TRANS/WP.29/GRSG/2005/8
4 February 2005

World Forum for Harmonization of Vehicle Regulations (WP.29)

PROPOSAL FOR SUPPLEMENT 1 TO THE DRAFT 02 SERIES OF AMENDMENTS TO
REGULATION No. 107

(M2 and M3 vehicles)

"Figure 1

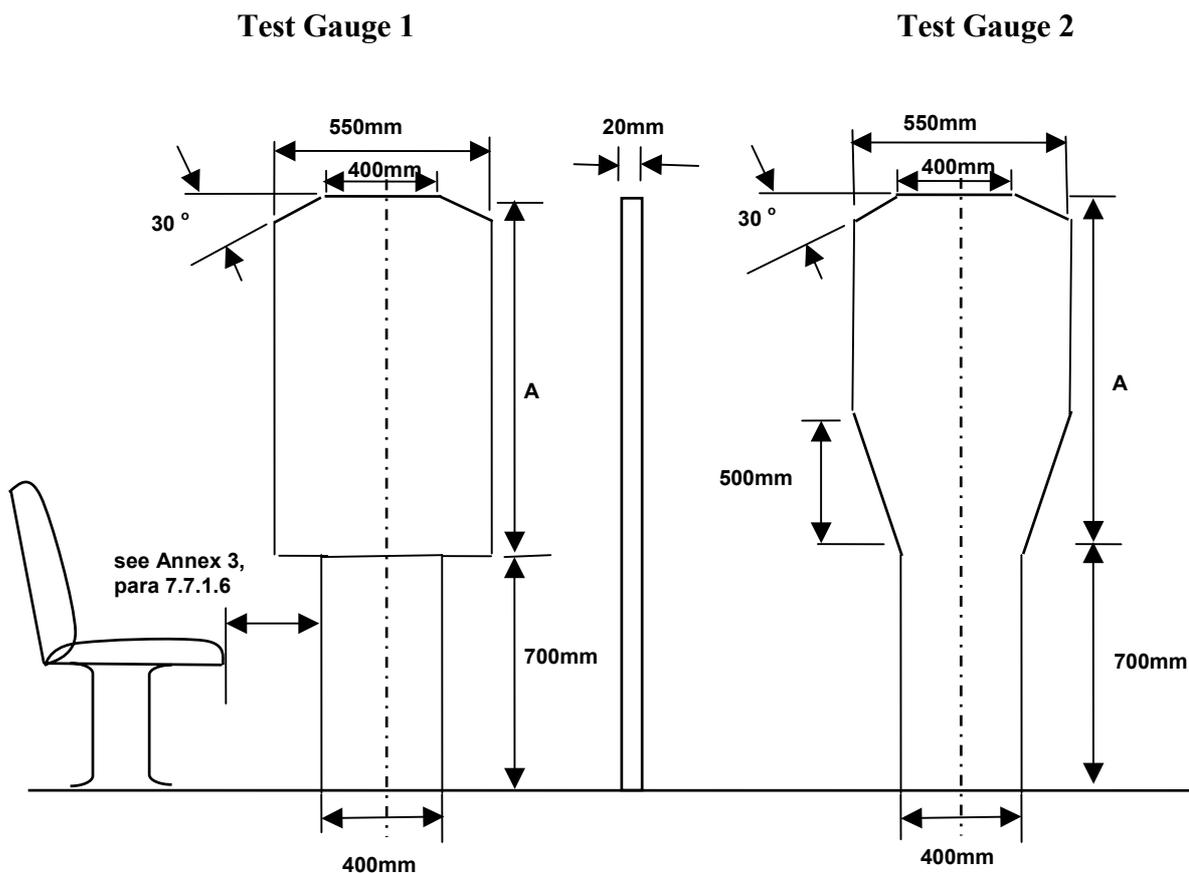
Figure 1, amend to read:

ACCESS TO SERVICE DOORS

Vehicle Class	Height of the upper panel (mm) (Dimension 'A' figure 1)	
	Test gauge 1	Test gauge 2
Class A	950 (*)	950
Class B	700 (*)	950
Class I	1100	1100
Class II	950	1100
Class III	850	1100

(*)For vehicles of Class A or B, the lower panel may be displaced horizontally relative to the upper panel provided that it is in the same direction."

"Figure 11b

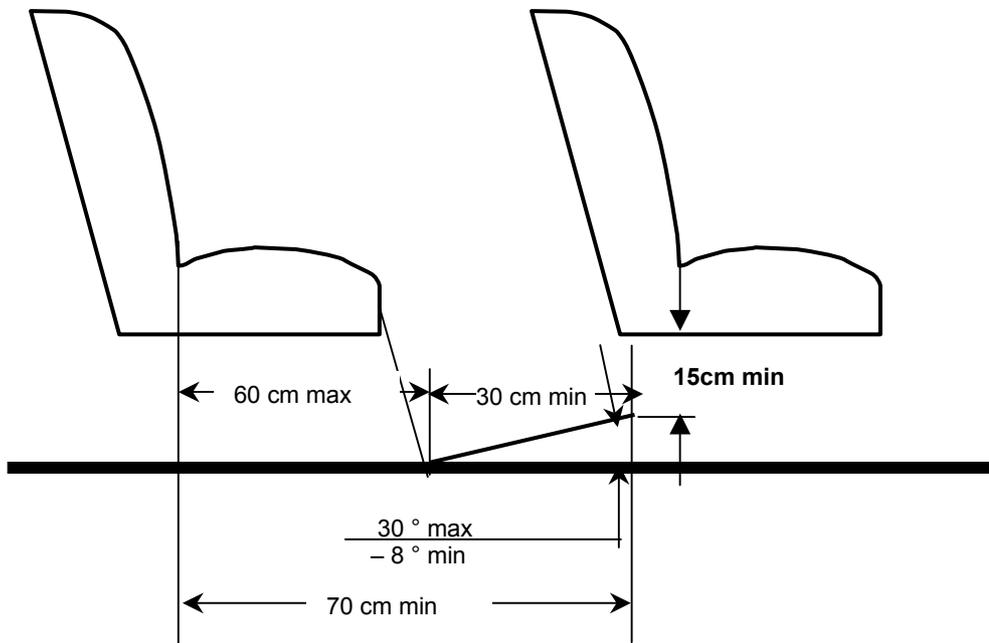
Insert a new Figure 11b, to read:

**SPACE FOR FEET OF SEATED PASSENGERS BEHIND A SEAT OR AT A SEAT
FACING THE GANGWAY
(see Annex 3, paragraph 7.7.8.5.2.)**

"Figure 27

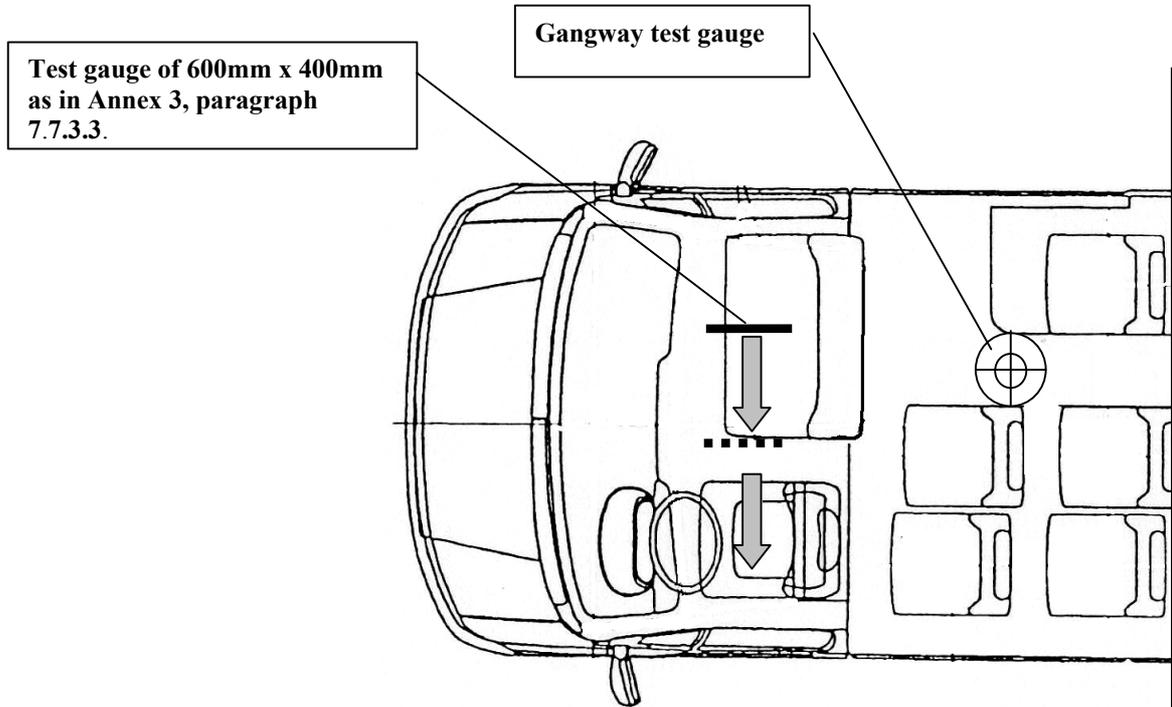
Insert new Figures 27 and 28, to read:

**ACCESS TO DRIVER'S DOOR
(See Annex 3, paragraph 7.6.1.7.2.)**

Figure 28

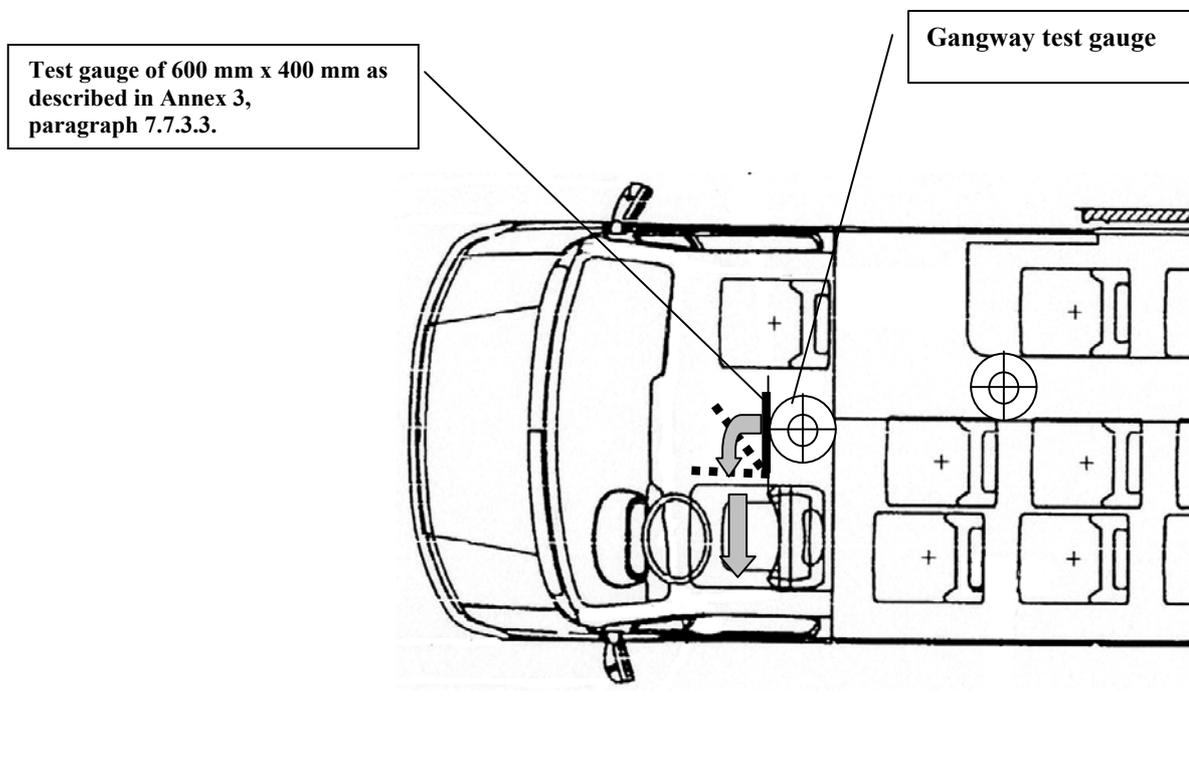
ACCESS TO DRIVER'S DOOR
(See Annex 3, paragraph 7.6.1.9.3.)
